**REQUEST FOR JOHN DIX/NICK HUFTON TO SPEAK AT COMMITTEE**

**Application No 21/3676/FUL – Land Formerly Known As British Gas Works Albert Road  
New Barnet Barnet EN4 9SH**

## Response to Fairview Plan Amendments

### **Appendix H Waste 7 Recycling:**

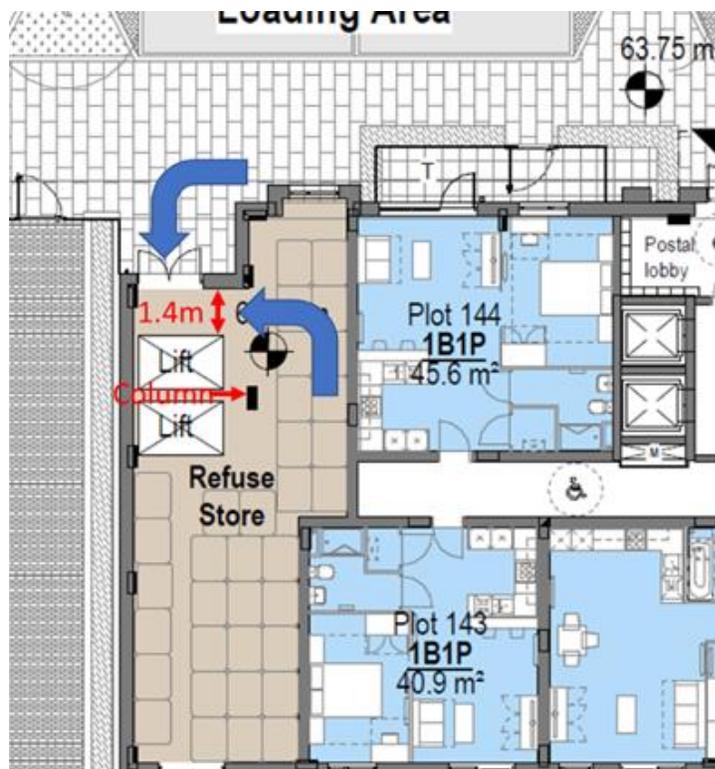
- No inclusion has been made for the storage of the 12 x 240 litre food waste bins which will be required for these six block of flats when food waste collections are re-introduced.
- All of the floor space is required to house the 35 x 1,100 litre bins with no circulation space that would allow bins to be easily moved in and out. This is in contradiction of Barnet’s waste collection policy which states “Bin stores will be large enough to allow gangway access to all bins without needing to arrange other bins in the space”

- The location of the service lift means that the gap between the lift and wall closest to the exit is only approximately 1.4 metres, yet a 1,100 litre bin is 1.1 metres deep and 1.38 metres wide. This means that it will be impossible for full bins to move out of the bin store and empty bins to move back into the bin store lift at the same time. There is also a structural column adjacent to the lifts which means that all bins from the front of the bin store will need to be cleared before bins from the rear of the store can be moved to the exit door. Forty seven bins will need to be moved up from the basement via the service lift and this is illustrated on the sketch opposite:
